Structural Special Inspections Report

PEARL PLACE BUILDING 1& 2

Portland, Maine
December 5, 2007

Structural Engineer of Record
Becker Structural Engineers, Inc.
75 York Street
Portland, Maine 04101

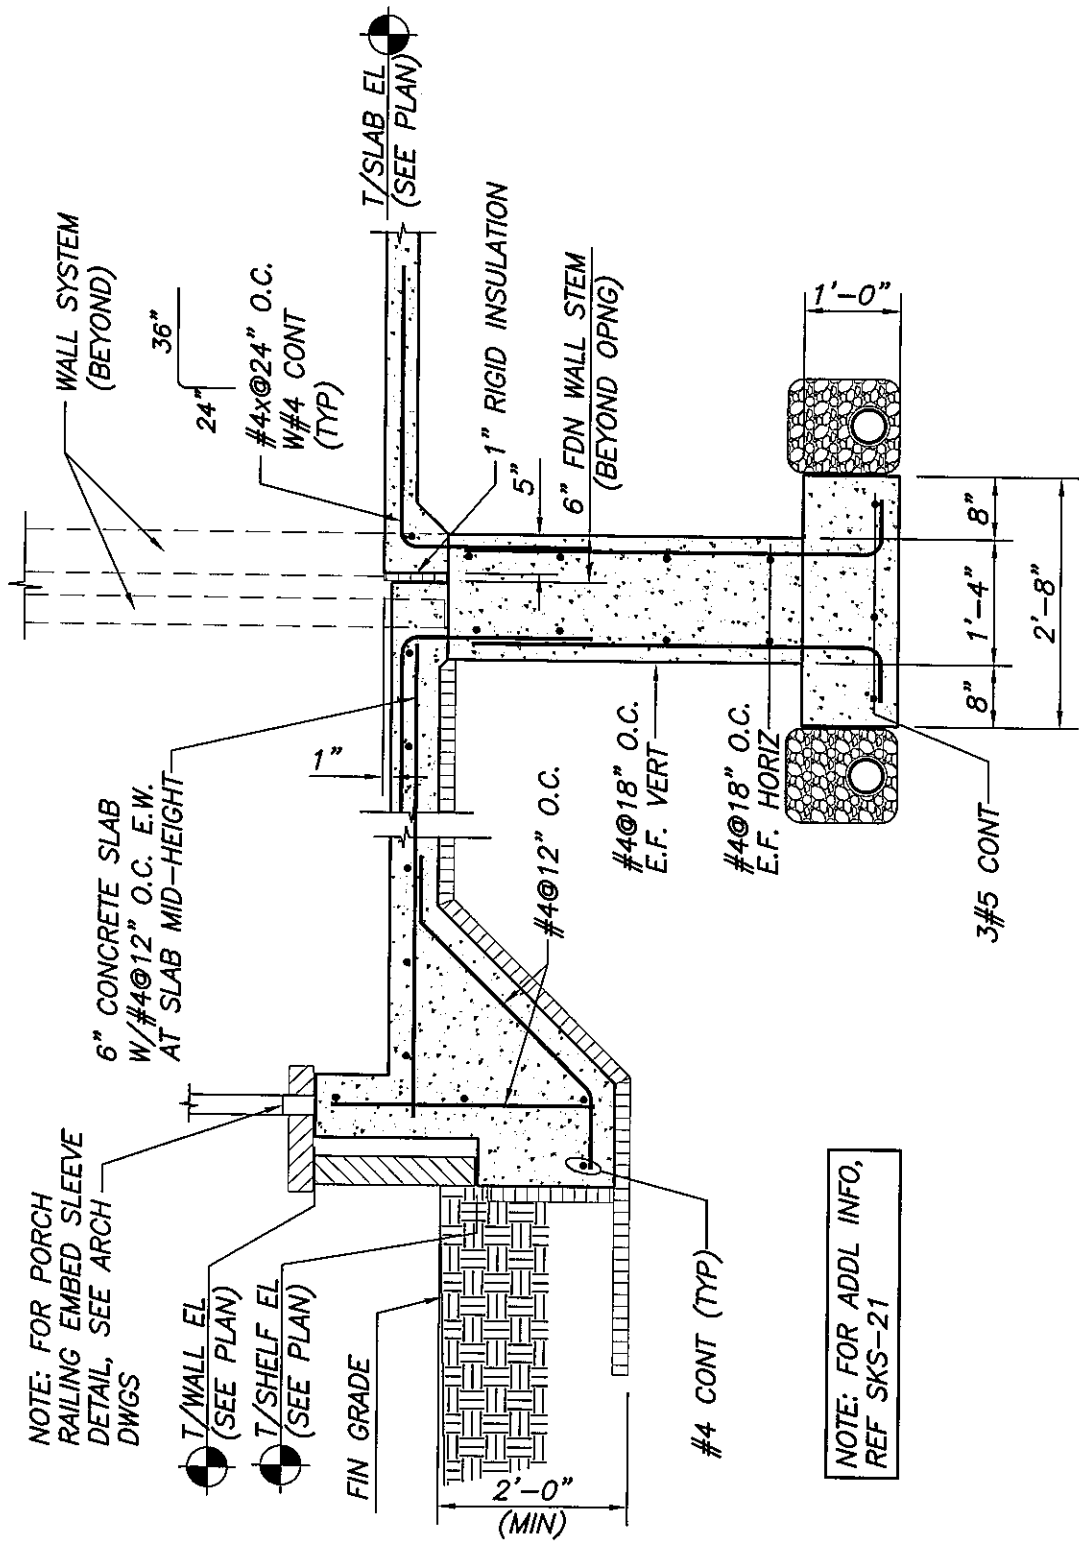
We have reviewed the detail (SSK-43) provided by Becker Structural Engineers, Inc. for the proposed patio foundation at unit 2-105. The detail appears acceptable. We offer the following comments:

- Compacted structural fill would also be acceptable as fill below the patio slab.
- The 2 inches of rigid insulation should consist of two 1 inch thick pieces with the joints between pieces offset.

SSK-17

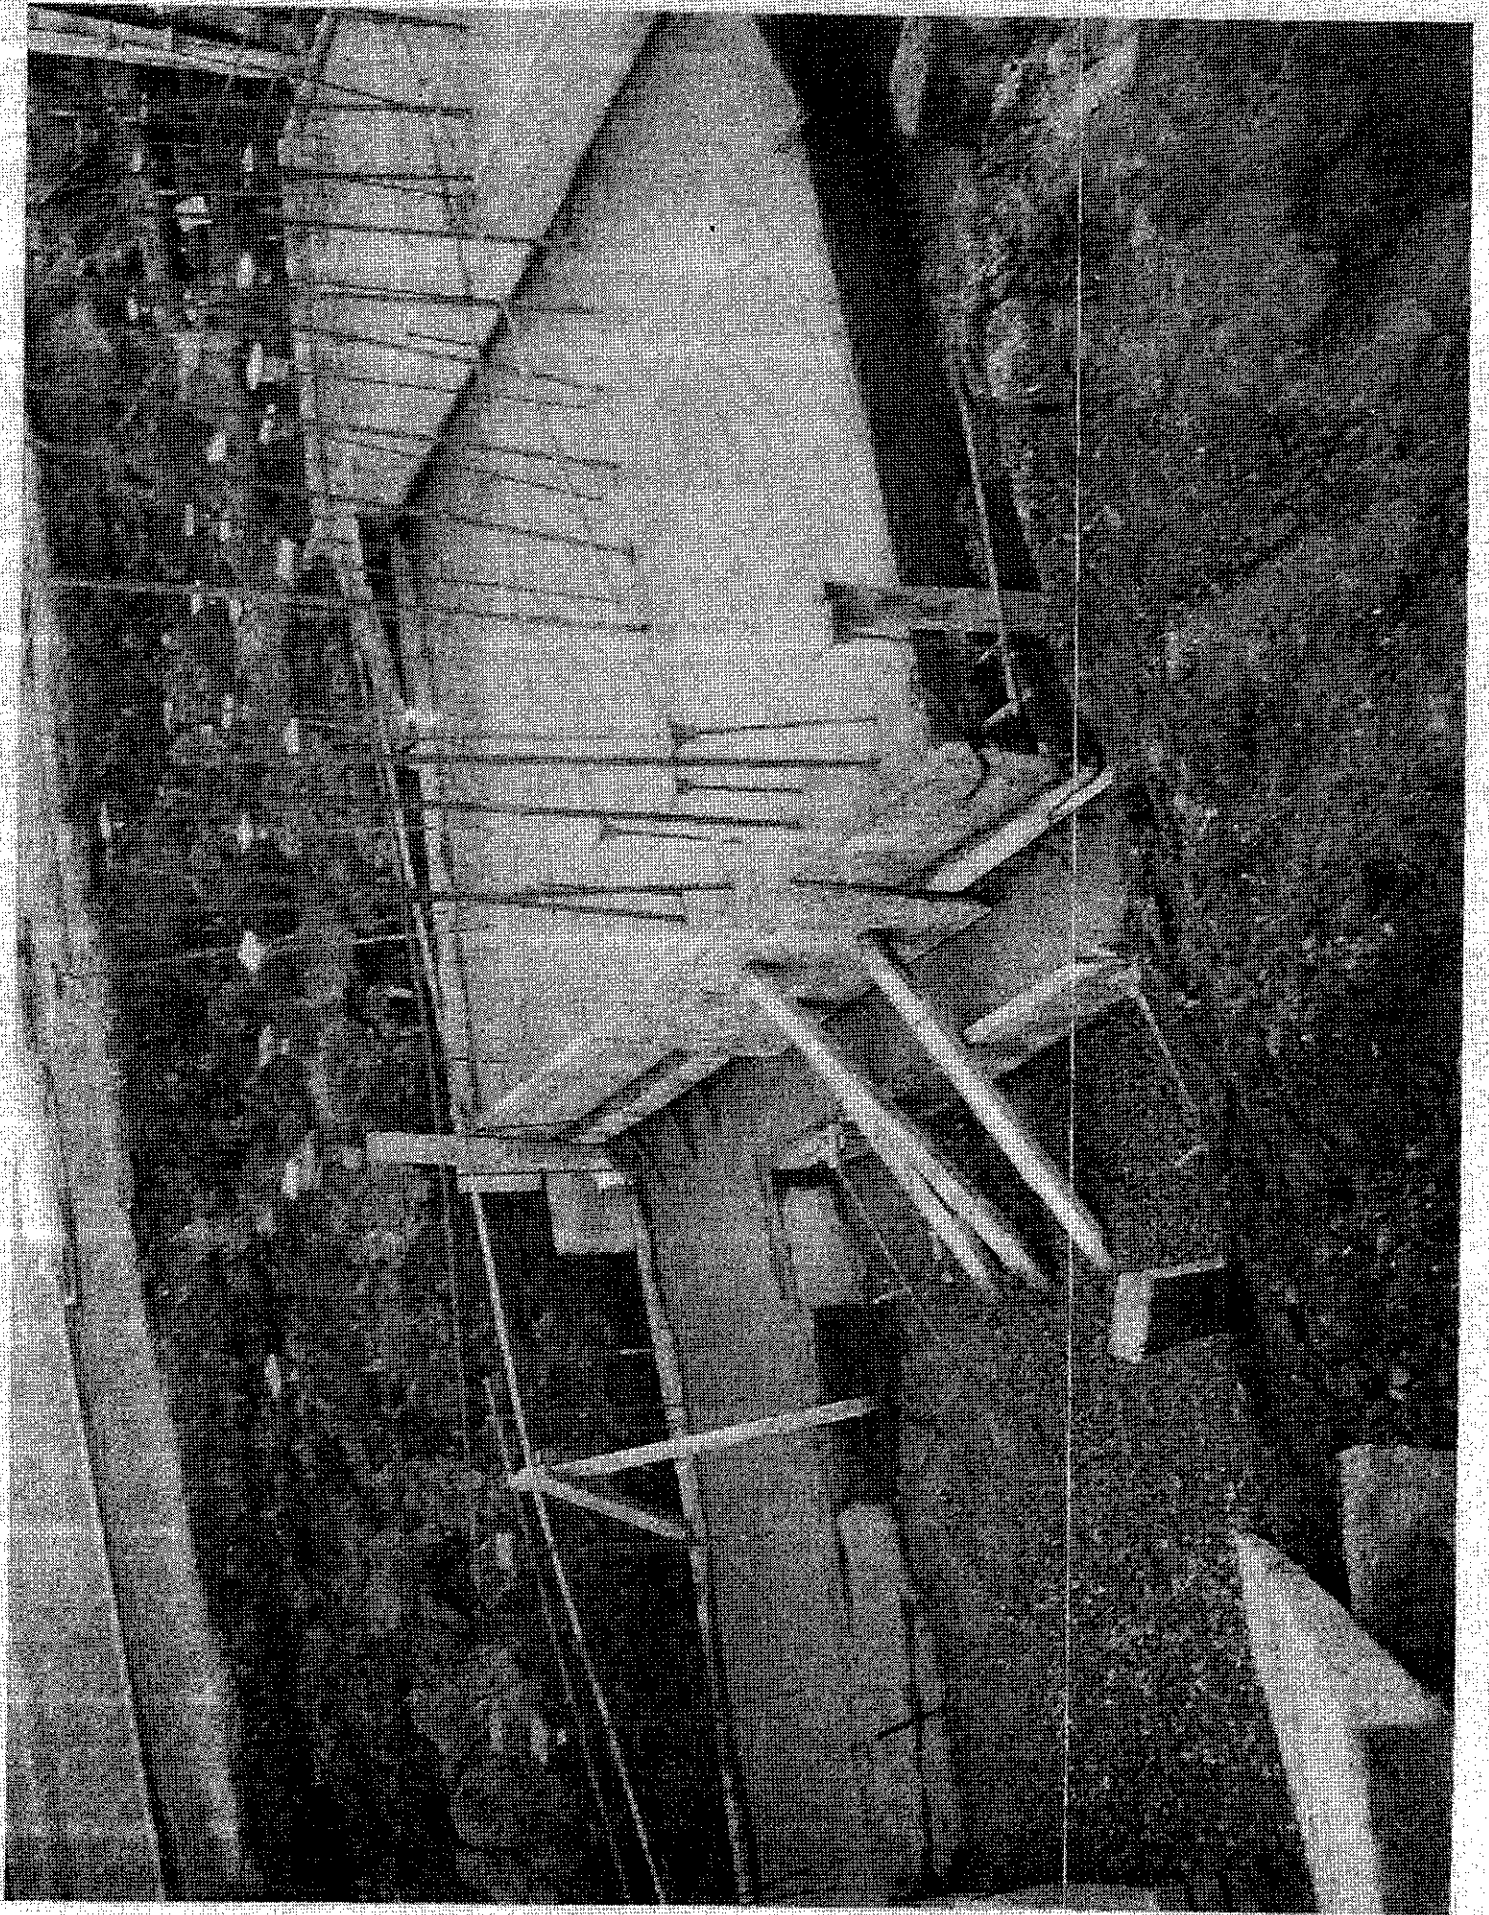
Pearl Place – Field Visit Items			
Item	System	Description	Status
1	B2- Foundation	The foundation footing plan right of Stair 2-1, towards Oxford Street, has not been poured correctly. This footing was to step down from (21'-0") to (17'-9") in 3 steps. Instead, it only steps once and remains high until reaching the interior retaining wall at the stair, then steps again beyond the interior retaining wall location. The base of the retaining wall was to be at Elev (17'-9") per plan. But as poured, the wall would begin at Elev (+20'-0") +/- . The configuration was not as shown on approved shop drawings, as it is not understood what the rebar configuration is. It is necessary that the placed foundation is removed to the extents shown on the attached SSK-17 (also see attached photo of existing condition). Note that this sketch was updated to include the addendum information at the area in question only.	OPEN 12/15/06

REMOVE SECTION OF
FOOTING AND
REPLACE TO MATCH

Bldg #2 Ftg Splice Detail

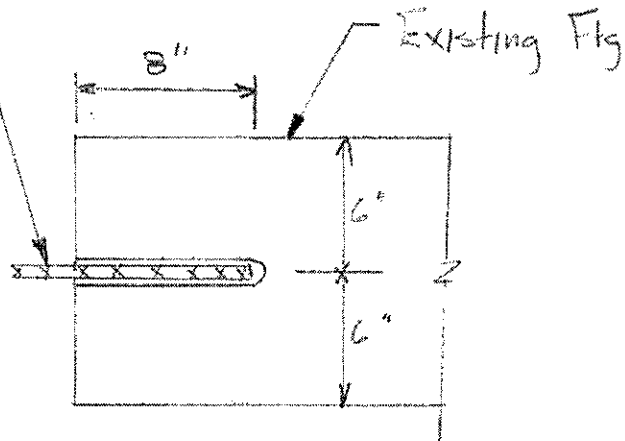
Drill a $5/8"$ ϕ Hole
8" Min. Embedment
Depth into Existing
Footing & Epoxy
Grout #4 x 4'-0"
Long Dowel

Use Hilti HIT HY 150/HIT-ICE
Epoxy

Photo 1: #7 bars should be closer to the inside face of the wall (more to the left)

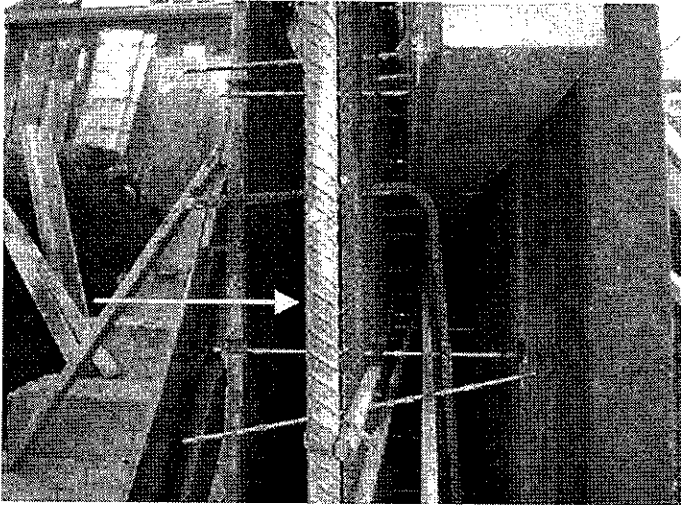
The retaining wall perpendicular to Oxford Street and further away from Pearl Street had the #7 bars in the wrong location (See Photo 1). This may affect the performance of the retaining wall, and may require additional work. This section of wall is not in tomorrow's concrete pour. Jim wants to look at this wall in further detail on Tuesday.

SSK-24

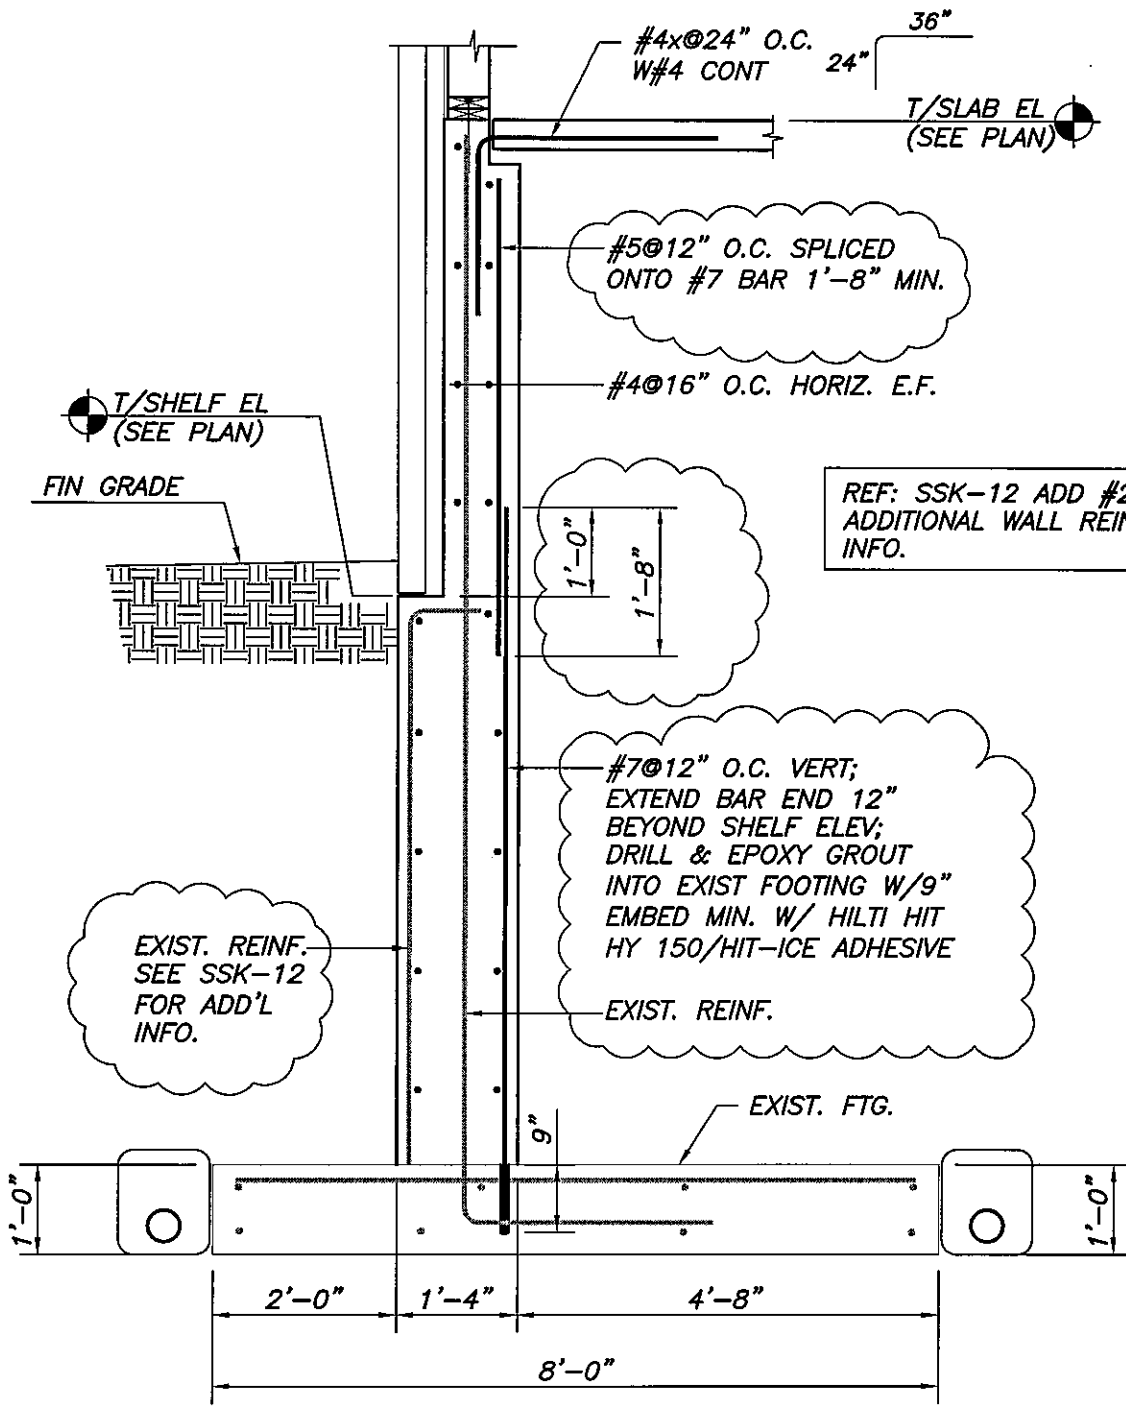
REF: SSK-12 ADD #2 FOR ADDITIONAL WALL REINF. INFO.

Photo 1: #7 dowels should be 2" from the inside face. The #7 dowels are adjacent to the brick shelf which is the outside face. The subcontractor should use SSK-25 to repair this discrepancy.

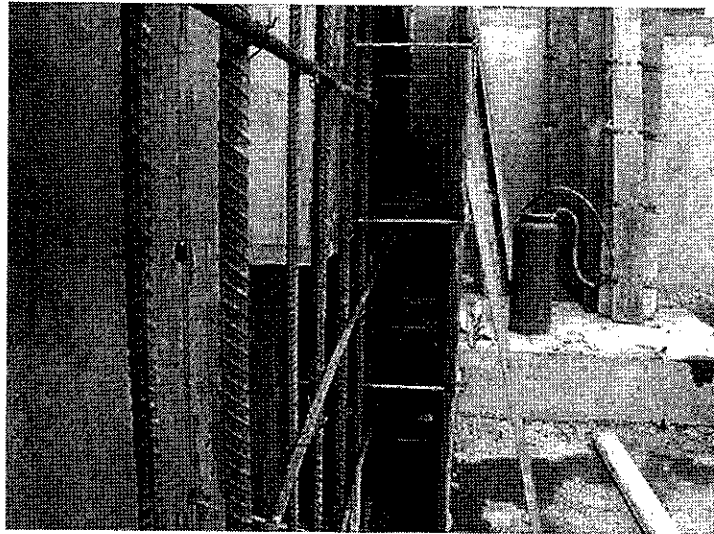
I observed from the scaffolding that the wall forms had been widened at section C (Reference bldg 2 foundation part plan) in order to comply with our structural drawings. The reinforcement, however, was not correct. When the wall form was relocated in order to widen the wall, the reinforcement needed to be relocated as well. I could also see that a section about 2'-0" long did not have reinforcement as specified in SSK-25. The wall reinforcement for this section should comply with our sketch SSK-25.

Photo: SMH#13

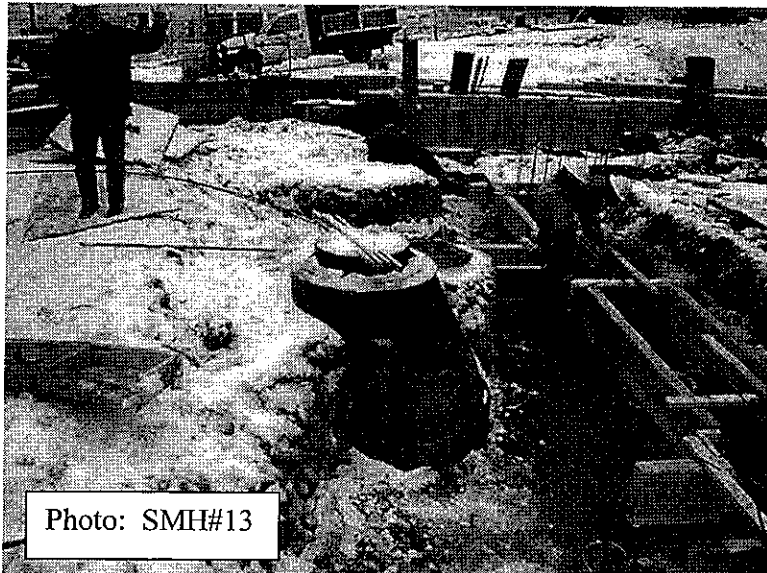
The general contractor informed me of a possible conflict with a sewer manhole and structural foundation wall at the community room 1-B01 entrance (Ref: A/1.1). After reviewing the civil site plan C-2, and a discussion with the architect, it appears that the sewer manhole SMH#13 may be in the wrong location. Please have the civil engineer verify the location of this unit.

Photo 1: Missing additional reinforcement around wall opening

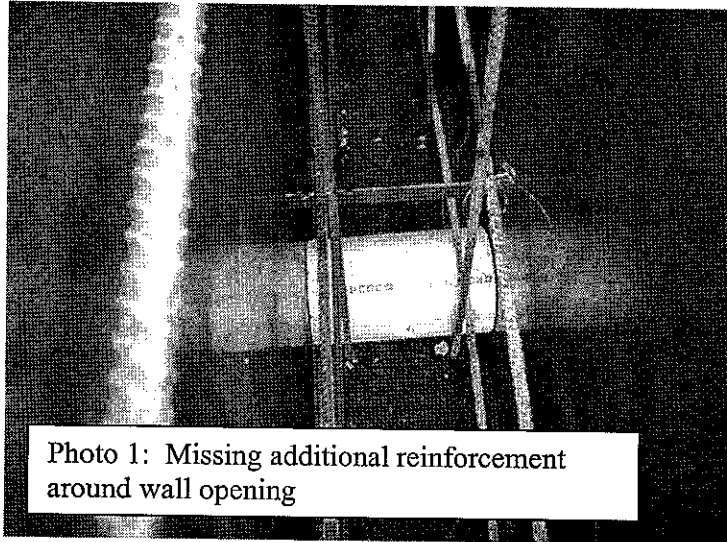
I observed the wall reinforcement for the north and northeast foundation wall and noted that one wall opening was missing additional reinforcement as per our detail on drawing S2.1 (See photo 1). The subcontractor was not on site, so I informed the general contractor of this discrepancy. All of the other reinforcement appeared to comply with our structural drawings.

Photo 1: Area of missing footing is highlighted

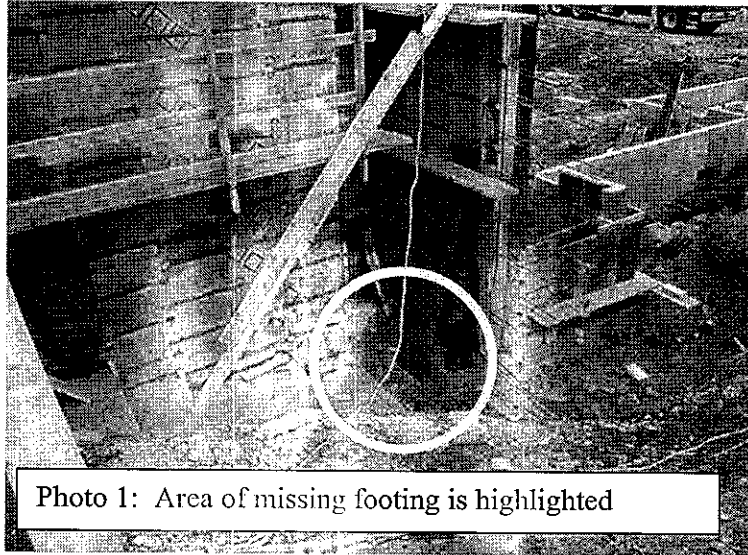
Photo 2: Ice within the formwork of today's proposed concrete placement
